SUBJECT: LICENSING ACTION REVIEWS FOR FARLEY UNITS 1 AND 2

Joseph M. Farley Nuclear Plant - Units 1 and 2
Proposed Administrative Technical Specification Change

Joseph M. Farley Nuclear Plant - Units 1 and 2
Proposed Administrative Technical Specification Change

Figure 6.2-1 Offsite Organization for Facility Management and Technical Support

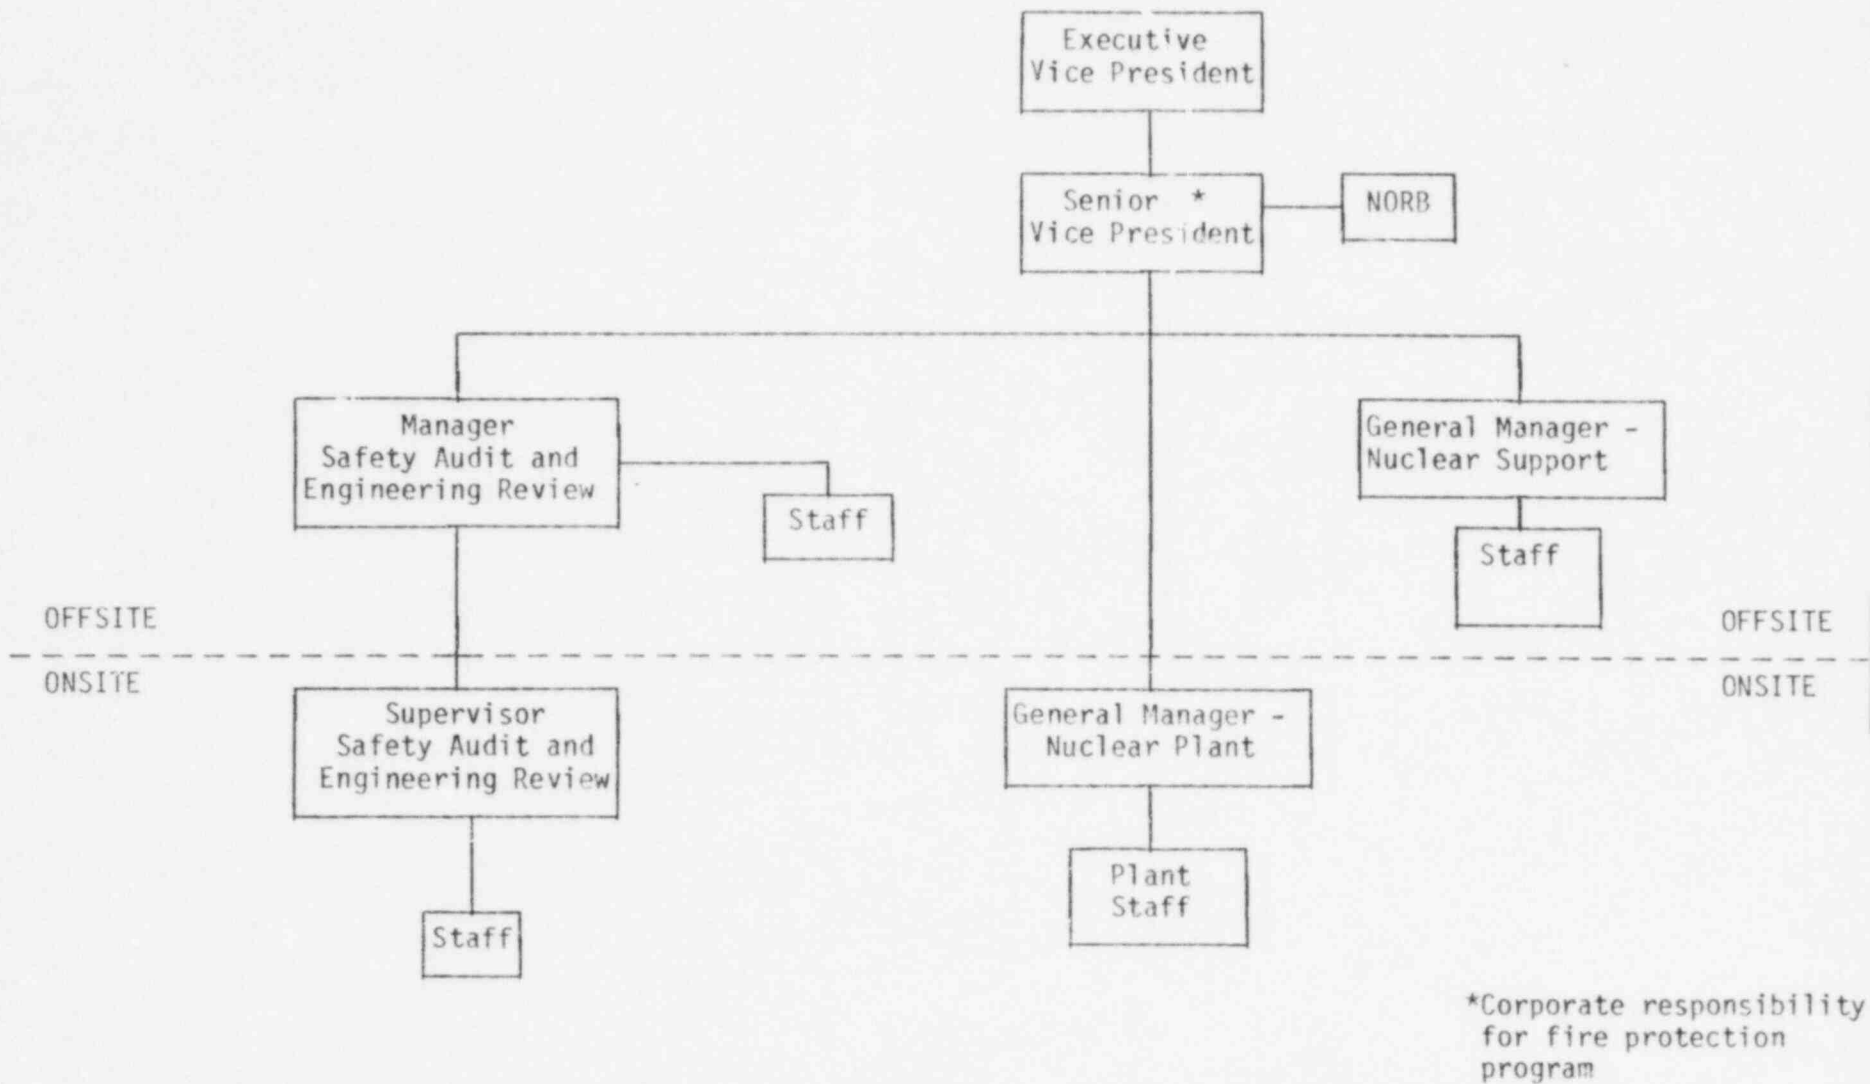
For the offsite organization it is proposed that Figure 6.2-1 and Section 6.5.2.2 be changed to combine and retitle the positions Manager - Nuclear Operations and Administration and Manager - Nuclear Engineering and Technical Support (NETS) as General Manager - Nuclear Support. The functional responsibilities of the Manager - Nuclear Operations and Administration and Manager - NETS have been delegated to the General Manager - Nuclear Support. The management change to a single General Manager - Nuclear Support also necessitates a change in the members of the Nuclear Operations Review Board (NORB). In order to preserve the current membership of four (4) persons in the NORB, it is proposed that the General Manager - Nuclear Plant become a permanent member of the NORB.

For the onsite organization it is also proposed that Figures 6.2-1 and 6.2-2 and Sections 6.1.1, 6.2.2.f.5, 6.4.1, 6.5.1.1, 6.5.1.2, 6.5.1.6.n, 6.5.1.7.a and c, 6.5.2.2, 6.5.2.6, 6.5.3.1.a through f and 6.5.3.2 be changed to reflect the title changes of Plant Manager to General Manager - Nuclear Plant, Assistant Plant Manager-Plant Operations to Assistant General Manager-Plant Operations, Assistant Plant Manager-Plant Support to Assistant General Manager-Plant Support, and the title changes of the plant superintendents to managers of their respective organizations. In addition,

Figure 6.2-2 Facility Organization

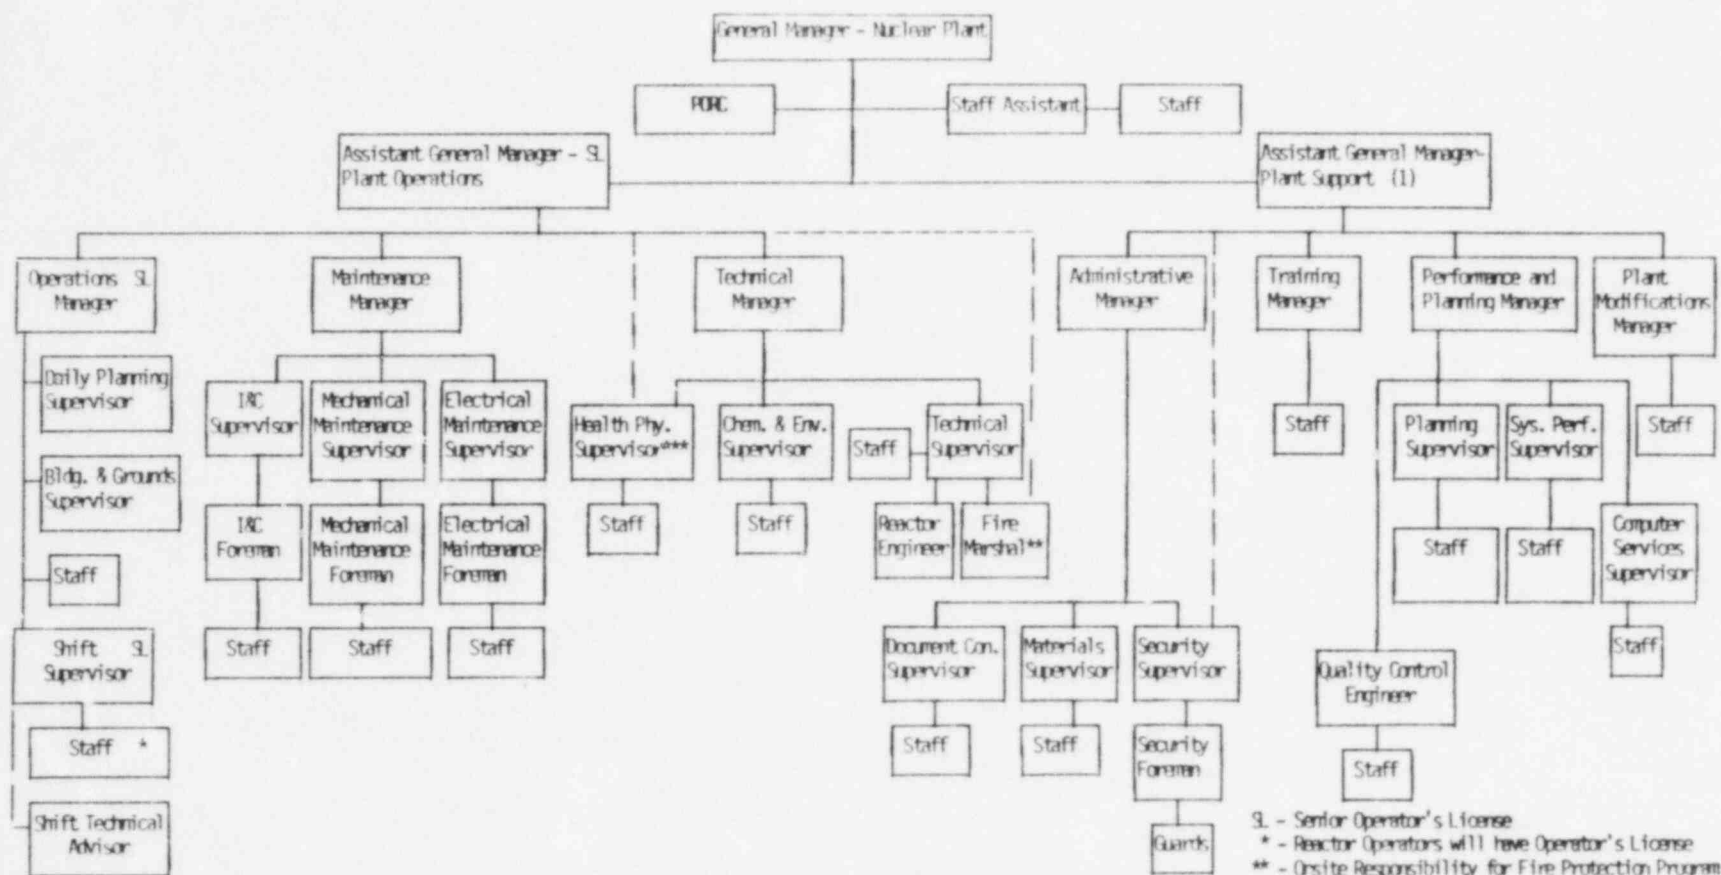
the functional responsibilities of mechanical maintenance and electrical maintenance are each proposed to be assigned to a separate supervisor. The Plant Modifications Supervisor position is proposed to be changed to Plant Modifications Manager. This position would report directly to the Assistant General Manager - Plant Support. The Computer Services Supervisor is proposed to report to the Performance and Planning Manager in lieu of the Technical Manager. The Operations Supervisor function has been replaced by an Operations Staff. The Shift Supervisor, Daily Planning Supervisor, Building and Grounds Supervisor, and Operations Staff would report directly to the Operations Manager.

*** In routine matters, the Health Physics Supervisor reports directly to the Technical Manager. In matters of radiation policy determination, interpretation or implementation (based upon the Health Physics Supervisor's judgment), the Health Physics Supervisor may report directly to the Assistant General Manager - Plant Operations.

Figure 6.2-1 Offsite Organization for Facility Management and Technical Support

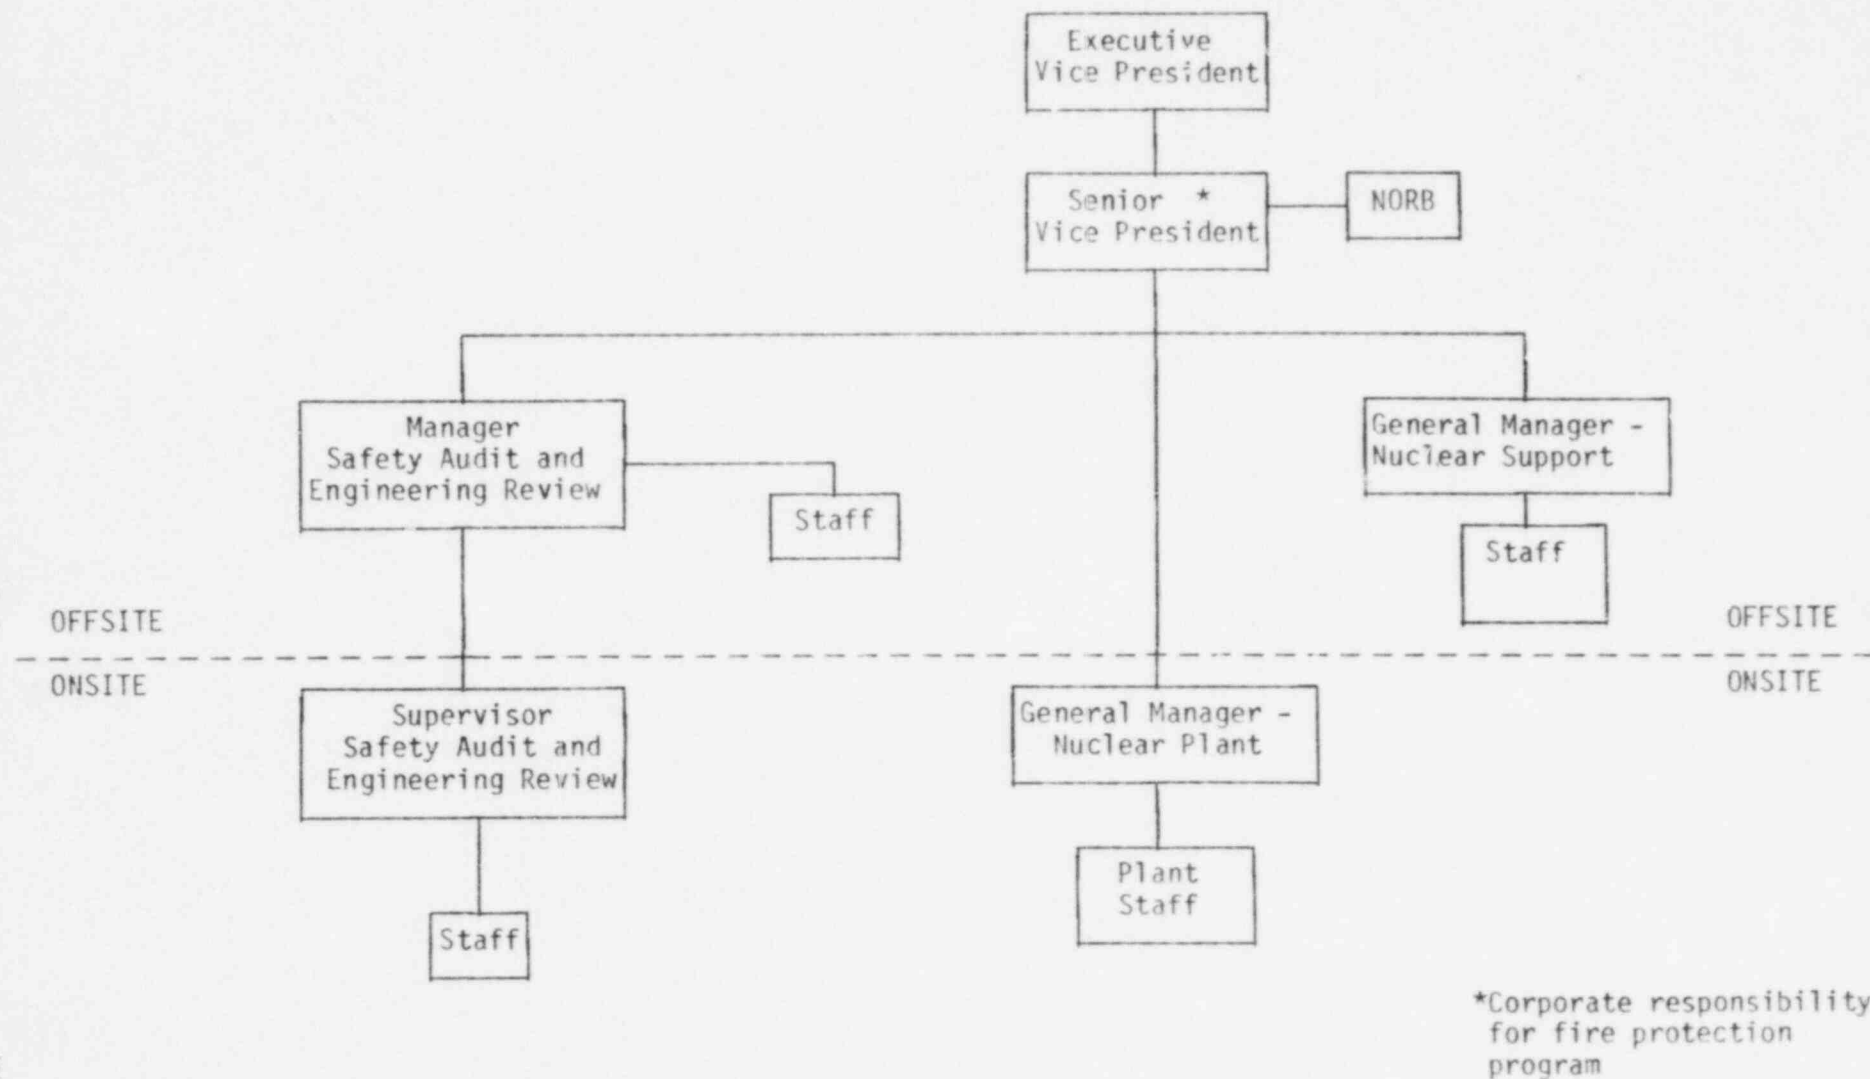
For the offsite organization it is proposed that Figure 6.2-1 and Section 6.5.2.2 be changed to combine and retitle the positions Manager - Nuclear Operations and Administration and Manager - Nuclear Engineering and Technical Support (NETS) as General Manager - Nuclear Support. The functional responsibilities of the Manager - Nuclear Operations and Administration and Manager - NETS have been delegated to the General Manager - Nuclear Support. The management change to a single General Manager - Nuclear Support also necessitates a change in the members of the Nuclear Operations Review Board (NORB). In order to preserve the current membership of four (4) persons in the NORB, it is proposed that the General Manager - Nuclear Plant become a permanent member of the NORB.

For the onsite organization it is also proposed that Figures 6.2-1 and 6.2-2 and Sections 6.1.1, 6.2.2.f.5, 6.4.1, 6.5.1.1, 6.5.1.2, 6.5.1.6.n, 6.5.1.7.a and c, 6.5.2.2, 6.5.2.6, 6.5.3.1.a through f and 6.5.3.2 be changed to reflect the title changes of Plant Manager to General Manager - Nuclear Plant, Assistant Plant Manager-Plant Operations to Assistant General Manager-Plant Operations, Assistant Plant Manager-Plant Support to Assistant General Manager-Plant Support, and the title changes of the plant superintendents to managers of their respective organizations. In addition,

Figure 6.2-2 Facility Organization

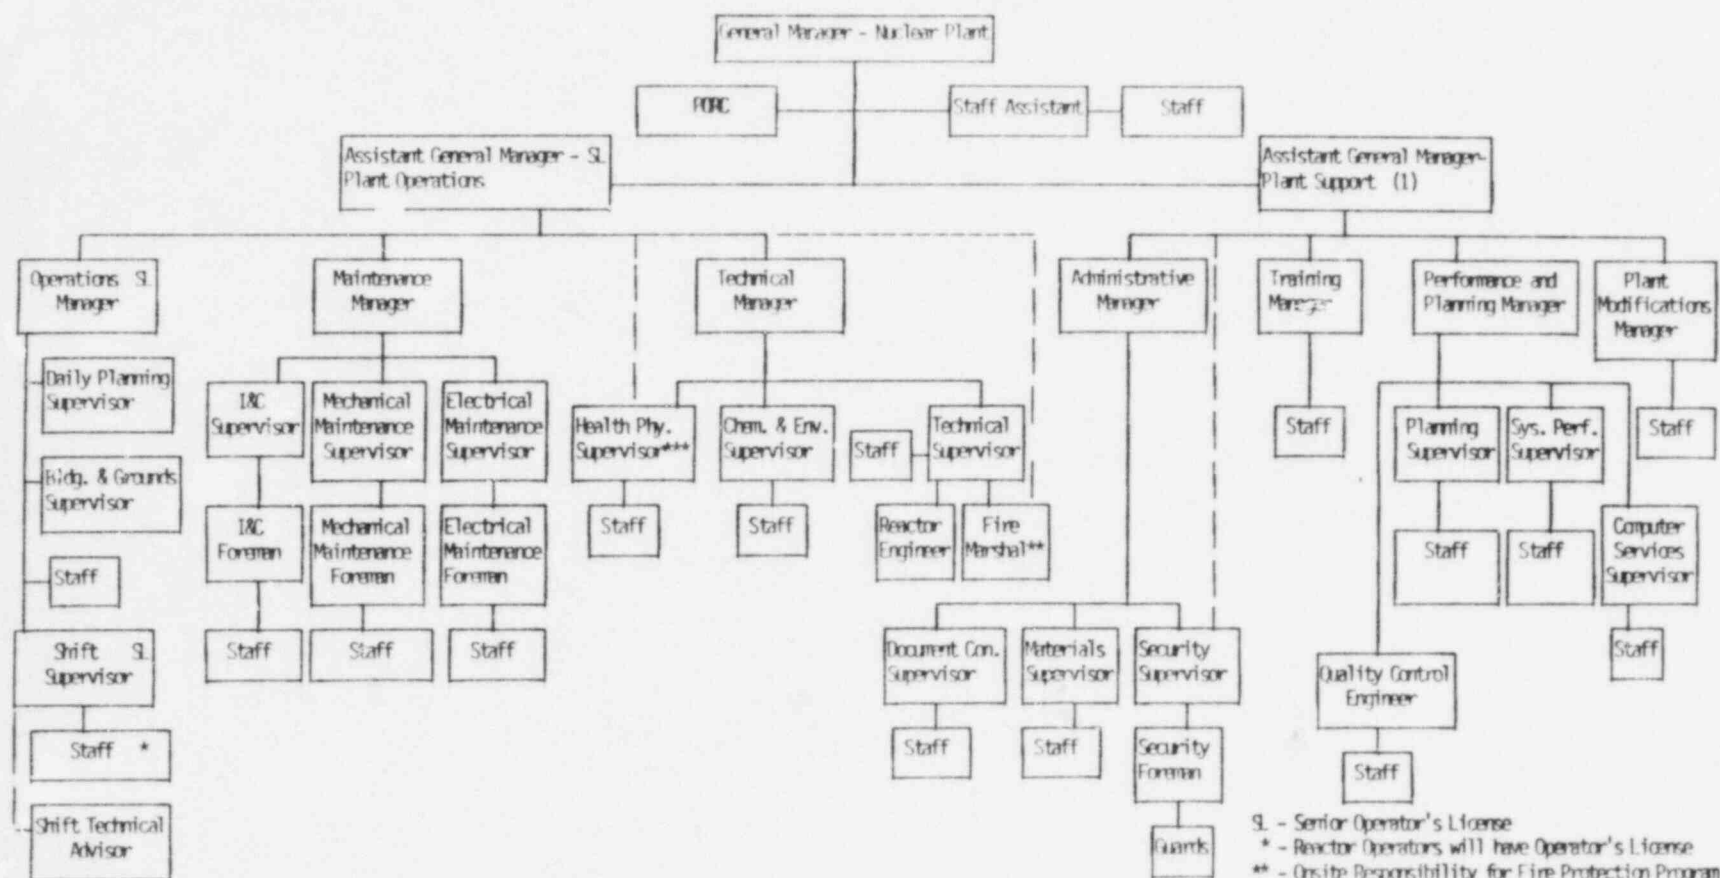
the functional responsibilities of mechanical maintenance and electrical maintenance are each proposed to be assigned to a separate supervisor. The Plant Modifications Supervisor position is proposed to be changed to Plant Modifications Manager. This position would report directly to the Assistant General Manager - Plant Support. The Computer Services Supervisor is proposed to report to the Performance and Planning Manager in lieu of the Technical Manager. The Operations Supervisor function has been replaced by an Operations Staff. The Shift Supervisor, Daily Planning Supervisor, Building and Grounds Supervisor, and Operations Staff would report directly to the Operations Manager.

*** In routine matters, the Health Physics Supervisor reports directly to the Technical Manager. In matters of radiation policy determination, interpretation or implementation (based upon the Health Physics Supervisor's judgment), the Health Physics Supervisor may report directly to the Assistant General Manager-Nuclear Operations.
